John S. Keenan
Vice President
Brunswick Nuclear Plant

BRUNSWICK STEAM ELECTRIC PLANT, UNIT NOS. 1 AND 2
DOCKET NOS. 50-325 AND 50-324/LICENSE NOS. DPR-71 AND DPR-62
REQUEST FOR LICENSE AMENDMENTS - REVISION OF SURVEILLANCE
FREQUENCY AND ACTION COMPLETION TIME FOR SUPPRESSION CHAMBER-
TO-DRYWELL VACUUM BREAKER STATUS

Basis For Change Request

Suppression Chamber-to-Drywell Vacuum Breaker (Unit 2)

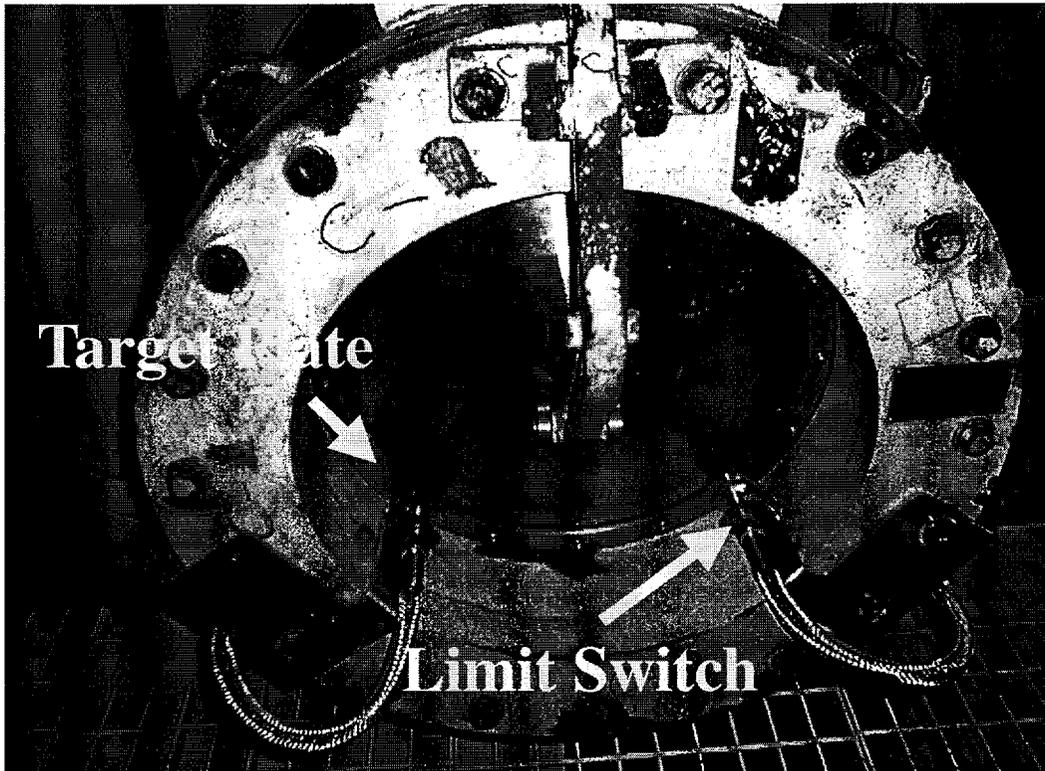
Each suppression chamber-to-drywell vacuum breaker is a self-actuating valve, similar to a check valve, which can be remotely operated for testing purposes. A photograph of a BSEP vacuum breaker is provided in Attachment 1.

CP&L is requesting approval of this license amendment application by August 1, 2001, due to a position indication problem associated with BSEP, Unit 2 vacuum breaker 2-CAC-X18C. On May 4, 2001, the closed indication for vacuum breaker 2-CAC-X18C was lost. In order to verify closure of the vacuum breaker, the approved alternate method for verifying vacuum breaker closure (i.e., a differential pressure test) was performed. The test verified that the vacuum breaker was closed.

The position indication problem is requiring routine use of the differential pressure test. Since loss of the closed position indication, four additional differential pressure tests have been performed. Each test has successfully verified that vacuum breaker 2-CAC-X18C is closed. Therefore, CP&L has concluded that only a closed position indication problem exists for vacuum breaker 2-CAC-X18C (i.e., the closed position indication is inoperable), and that the vacuum breaker is operable.
